HOMESTEAD NORTH AT STERLING RANCH FILING 3

GRADING AND EROSION CONTROL PLAN

STREET IMPROVEMENT PLAN

STORM PLANS

HOMESTEAD NORTH AT
STERLING RANCH FILING 3
COVER SHEET

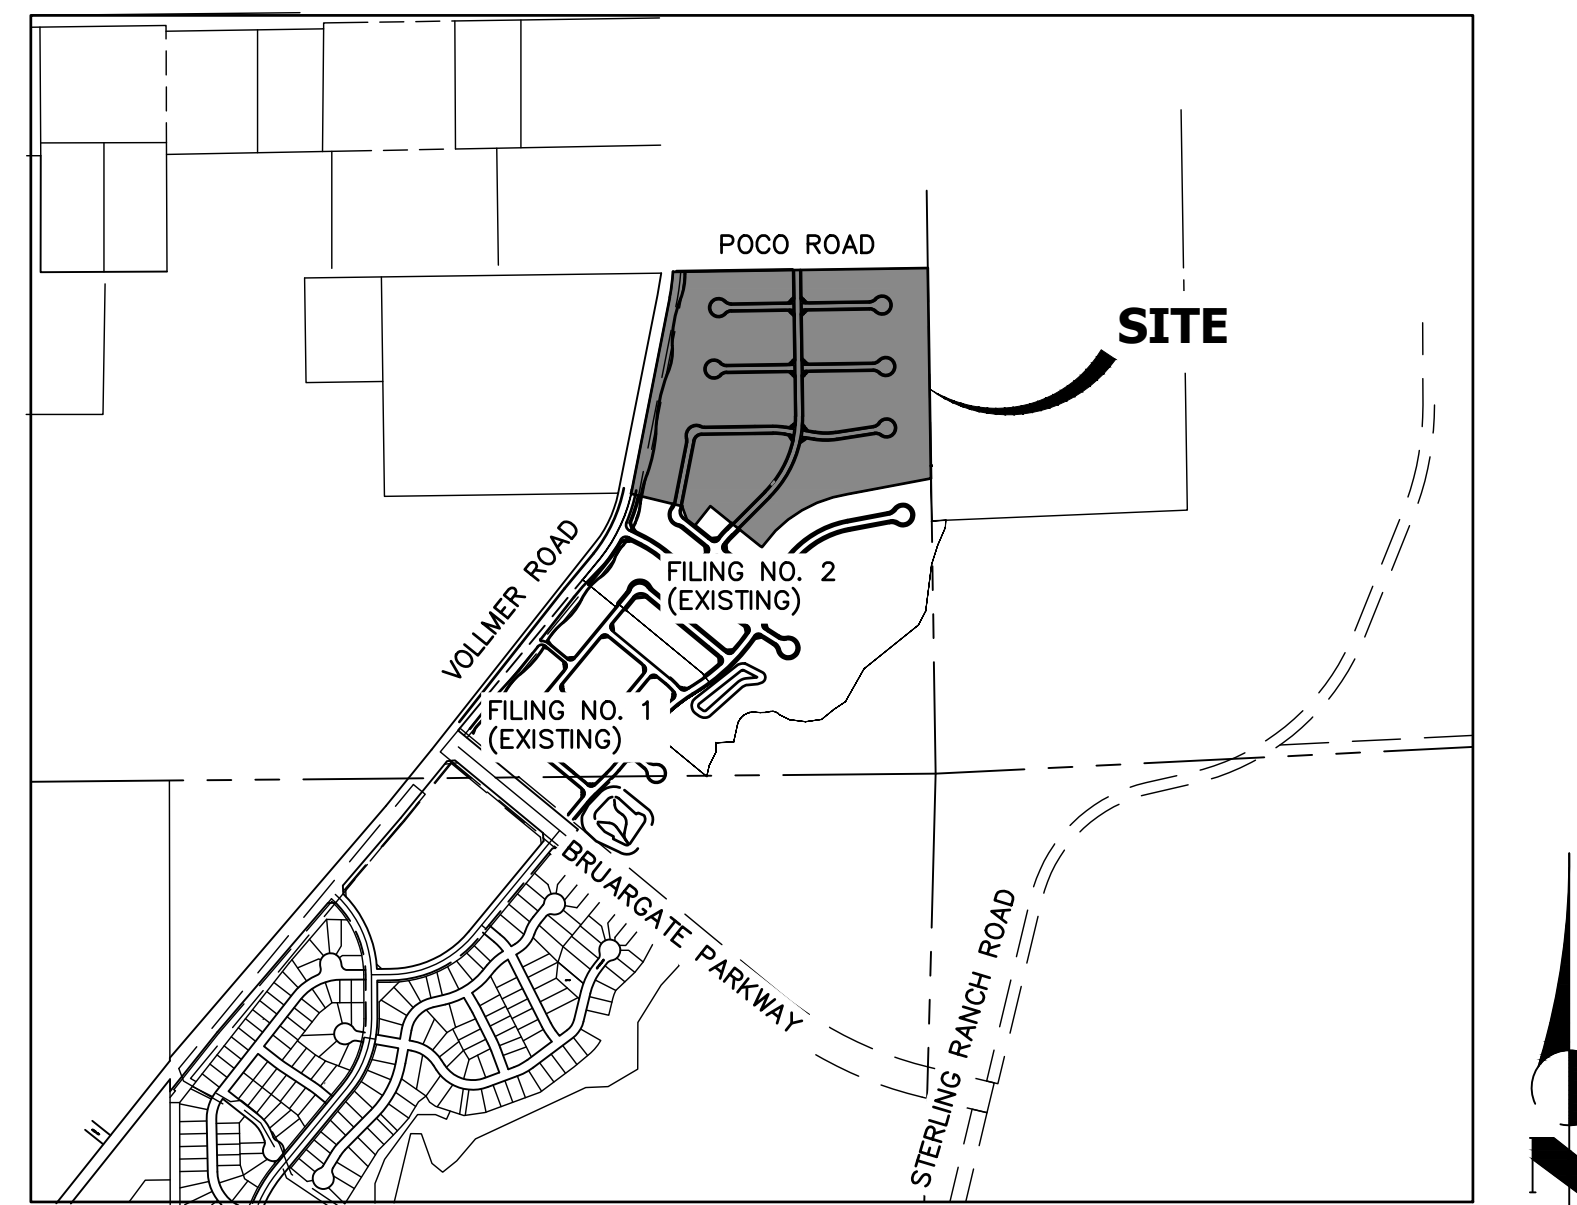
Add text:
PCD Filing No.: SF22229

JR Response:addressed

HOMESTEAD NORTH AT
STERLING RANCH FILING NO. 3
COVER SHEET

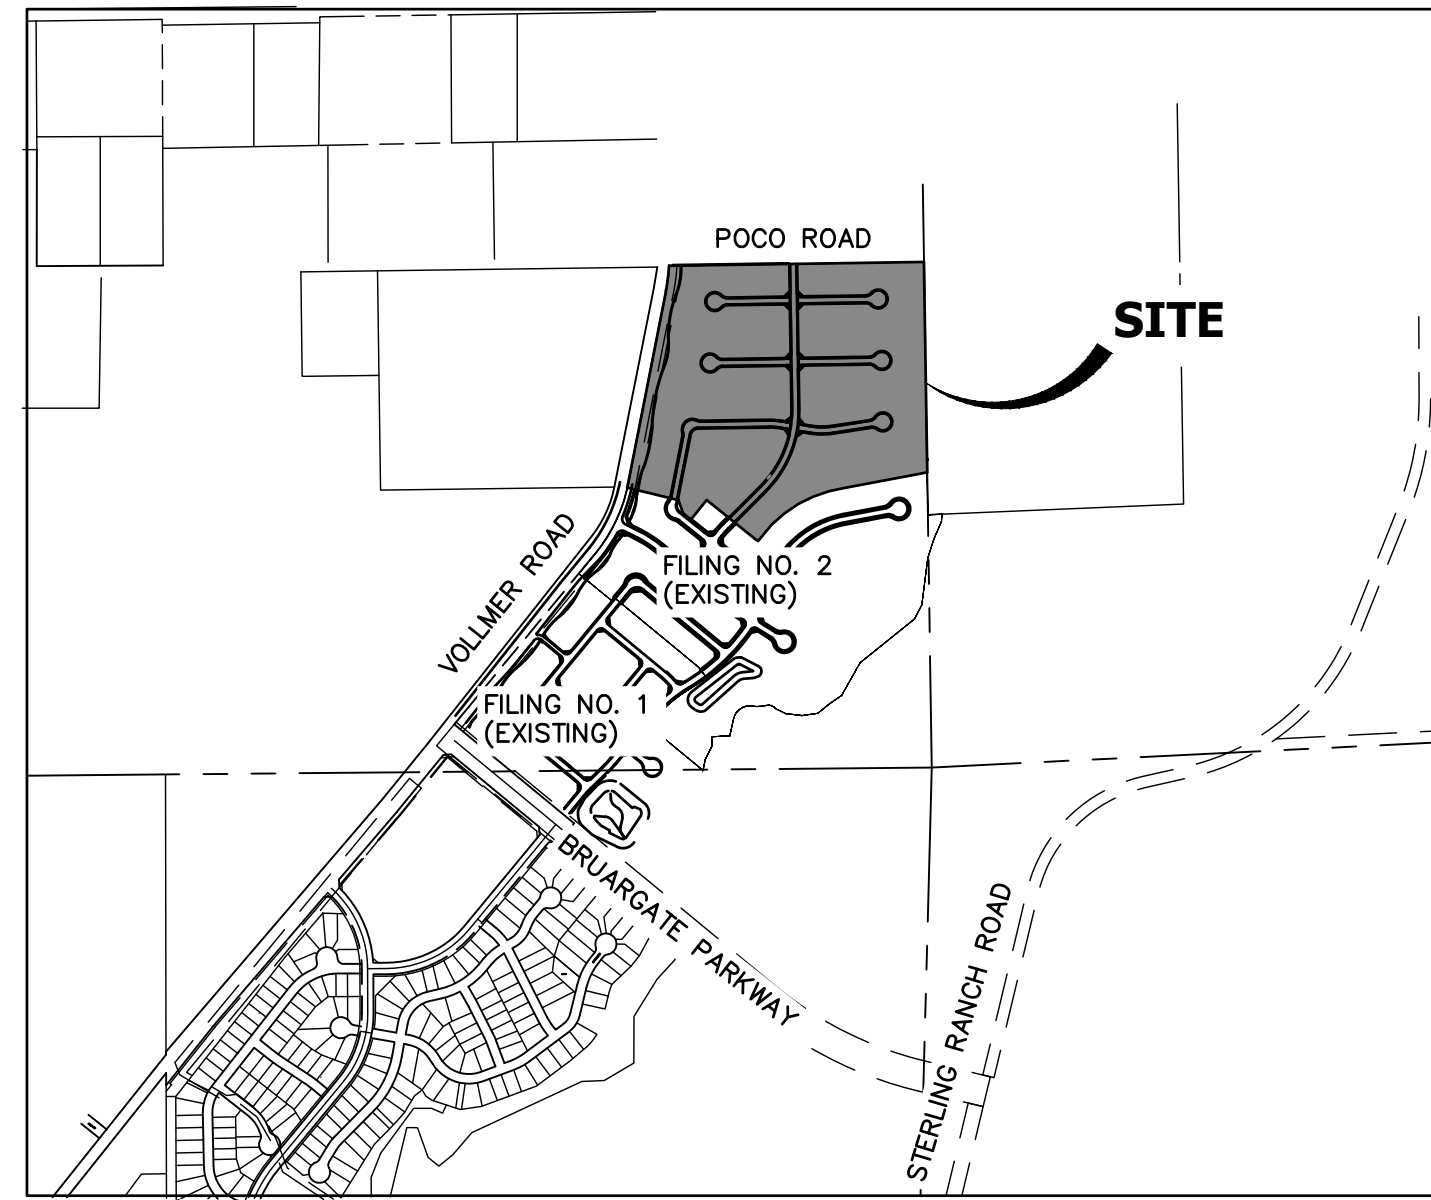
Update sheet index

Remove Interim
JR Response: Updated.

JR Response: Updated.

HOMESTEAD NORTH AT STERLING RANCH FILING NO. HORIZONTAL CONTROL PLAN

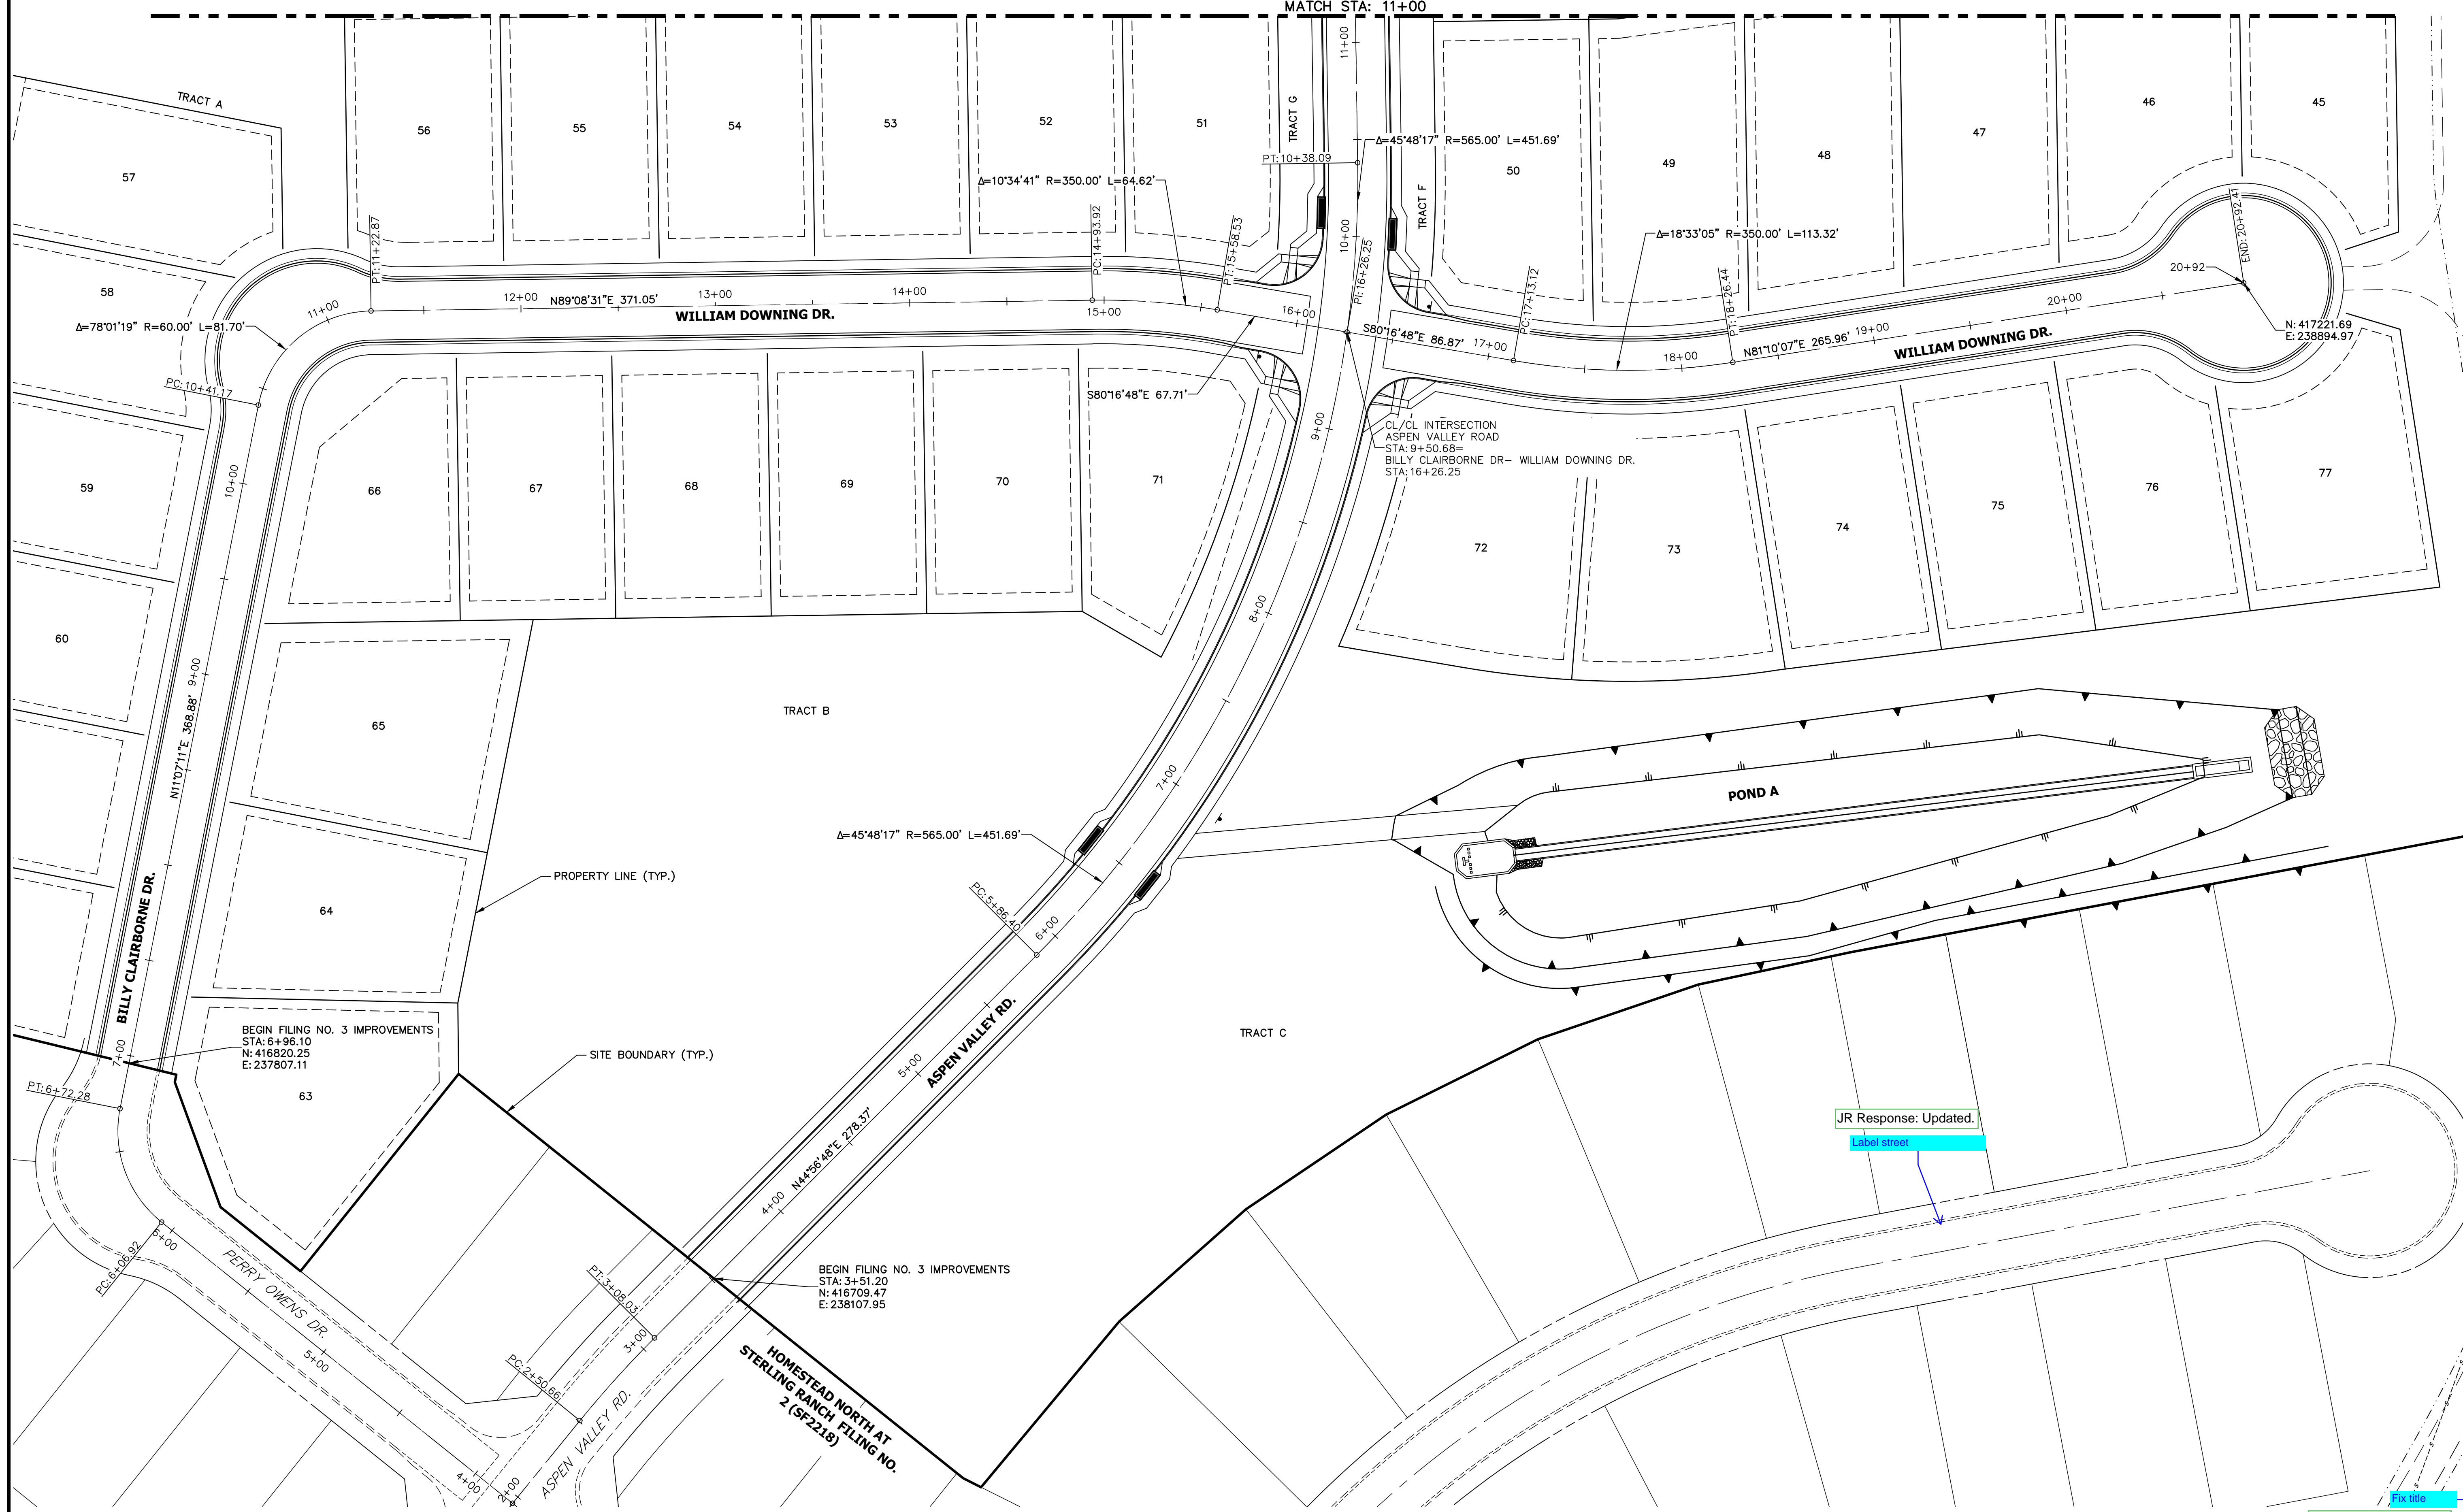
Fix title

JR Response: Updated.
